## Product Change Notification / SYST-25OAFH097

ERRATA - PIC16(L)F15354/55 Family Silicon Errata and Data Sheet Clarification Errata Document Revision

## PIC16(L)F15354/55 Family Silicon Errata and Data Sheet Clarifications

### 2.1 Figure 37-5: Clock Timing

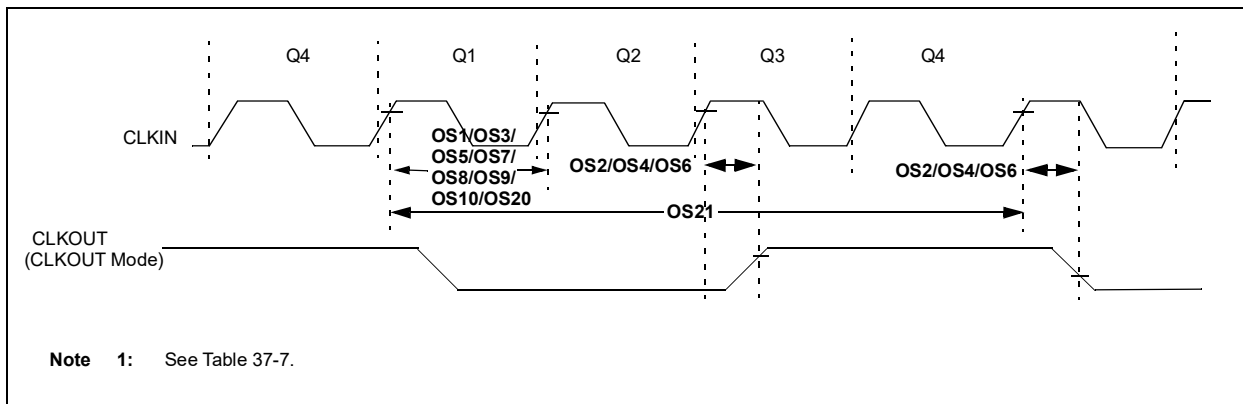
Figure 37-5 incorrectly shows the location of parameters OS1, OS2, OS3, OS4, OS5, OS6, OS7, OS8, OS9, OS10, OS20 and OS21. The correct location for the above-mentioned parameters is depicted in the following figure.

### 2.2 Figure 37-9: Brown-Out Reset Timing and Characteristics

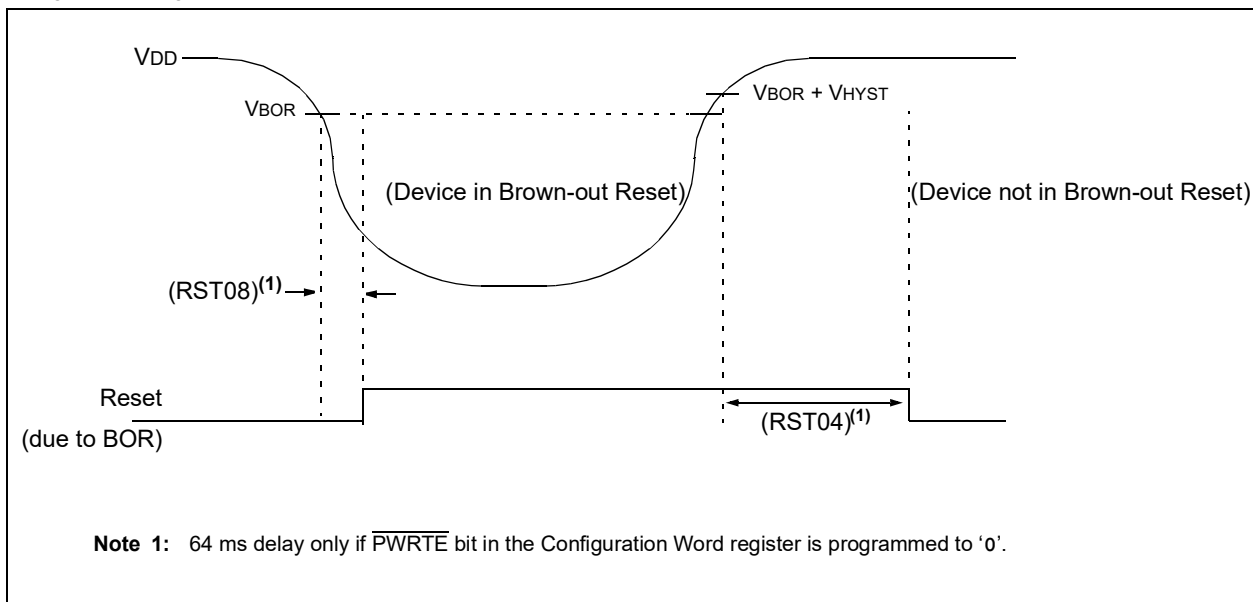
Note 1 in Figure 37-9 is incorrect. The correct note along with the figure is depicted below.
